**Cobra Motorcycle Mfg.**

## TSB01611 New style Clutch Shoes

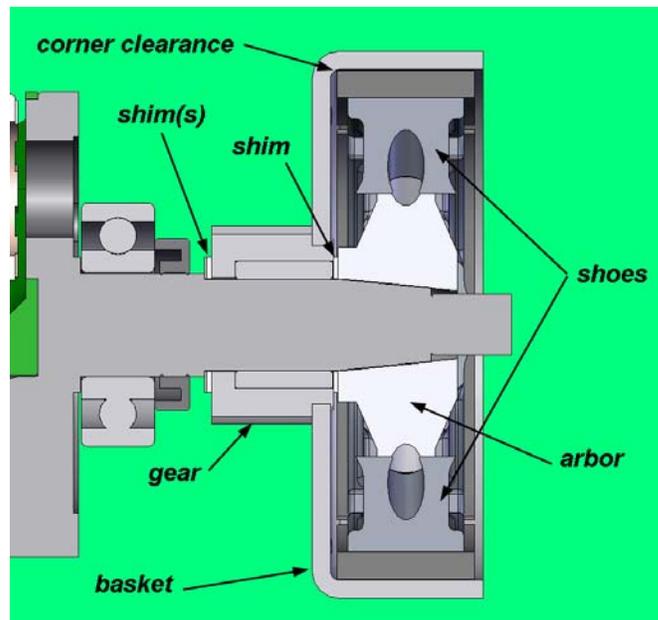
Cobra is switching over to a new manufacturing process to produce the aluminum base for our clutch shoes (see picture below left).

This style of shoes are slightly wider and require an ECMU0040 (0.8mm or 0.030" spacer) between the clutch arbor and the clutch basket to avoid undesired contact. If the shoes are used with the latest clutch arbor (shown on the right, with the identification groove) then there is space on the crankshaft for an ECMU0040 between the arbor and the basket as well as one behind the basket as they always has been. This will insure that the shoes have corner clearance with respect to the radius inside the clutch basket (see below).

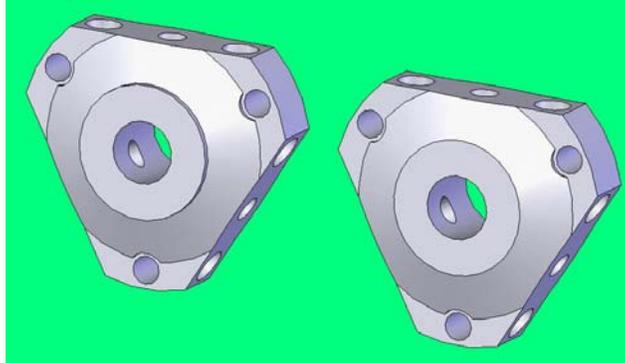
If the shoes are being applied to an older arbor (shown above without the identification groove), the ECMU0040 (0.8mm or 0.030" spacer) is still required between the arbor and the basket but there will likely not be space for the usual shim behind the basket. In fact depending on the age of the arbor, it may not be possible to get a shim between the arbor and the basket. If this is the case, then it may be necessary to take a file and create a 1.0mm (0.040") chamfer in the edge of the shoes facing the clutch basket as shown below.
